PERFORMANCE SPECIFICATION SHEET

FILTERS AND CAPACITORS, RADIO FREQUENCY INTERFERENCE, HERMETICALLY SEALED, STYLE FL15

This amendment forms a part of MIL-F-15733/27C, dated 11 August 1986, and is approved for use by all Departments and Agencies of the Department of Defense

FOR DASH NUMBERS 0014 AND 0015

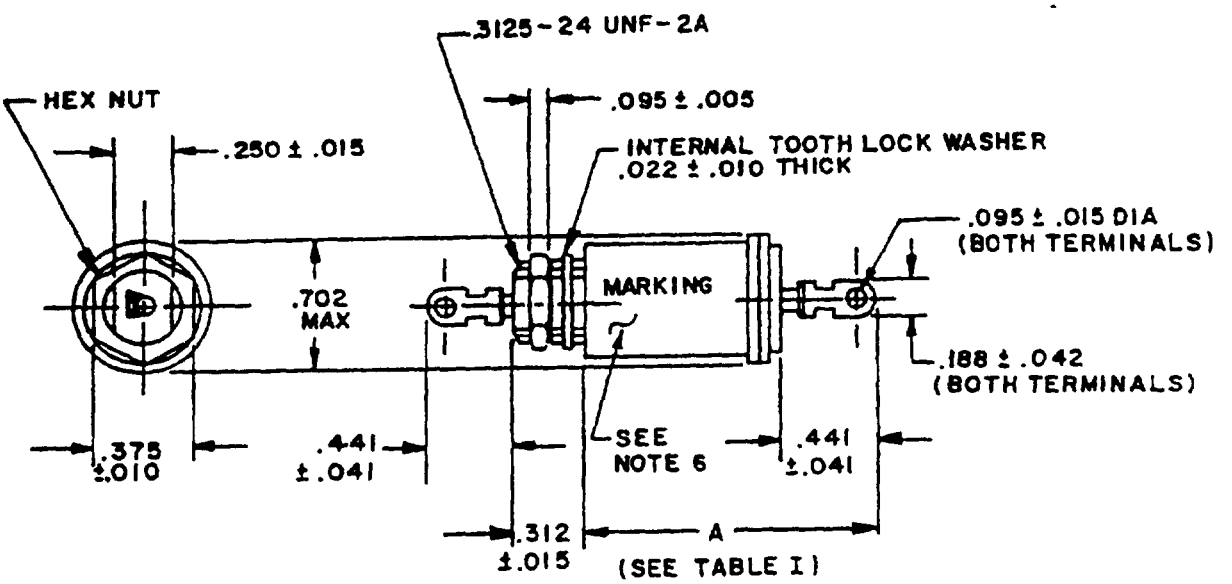
FIGURE 1. Delete the detail drawing for dash numbers 0014 and 0015 and substitute the following:

FIGURE 1: Delete the terminal detail drawing.

FIGURE 1, add note 8 as follows:

"8. Recommended mounting torque: 60 inch-ounces ±4 inch-ounces."
